## TELEDYNE CONTINENTAL® AIRCRAFT ENGINE

## service bulletin

M90-17 Supersedes M83-10R.1 and M77-14R.1 Technical Portions Are FAA Approved

SUBJECT: CRANKCASE INSPECTION CRITERIA

FIGURE 2 O-200 CASE

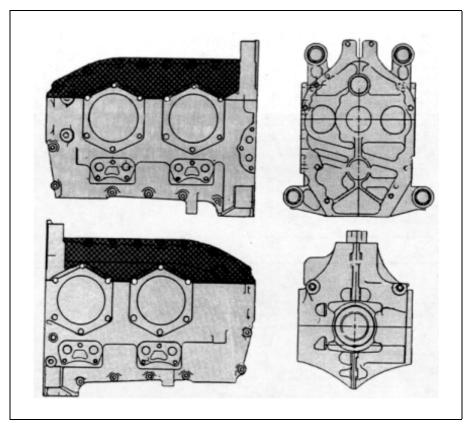
Critical (gray) and non-critical (dark gray) areas are illustrated in Figures 2,3,4,5,6 & 7. If a crack is observed in any of the non-critical (dark gray) areas less than two (2) inches in length, the crack should be scribe marked at its extremities and re-inspected for crack progression at the next 50 hours of operation, see Figure 1. If no crack progression is observed and no additional cracks are found, continue to re-inspect at regular intervals not to exceed 100 hours duration.

If a crack is observed in any of the <u>non-critical</u> (dark gray) areas more than two (2) inches in length or if a previously observed crack has progressed to two (2) or more inches in length, repair or replace the crankcase or engine prior to further flight. If any crack is observed in a <u>critical</u> (gray) area, repair or replace the crankcase or engine prior to further flight.

- A. Any crack in the critical (gray) area.
- B. Any crack two (2) inches or more in length in the non-critical (dark gray) area.
- C. Any size crack that is leaking oil (not seeping).
- D. Major overhaul with crankcases having lower numbers than set forth in Table 1.
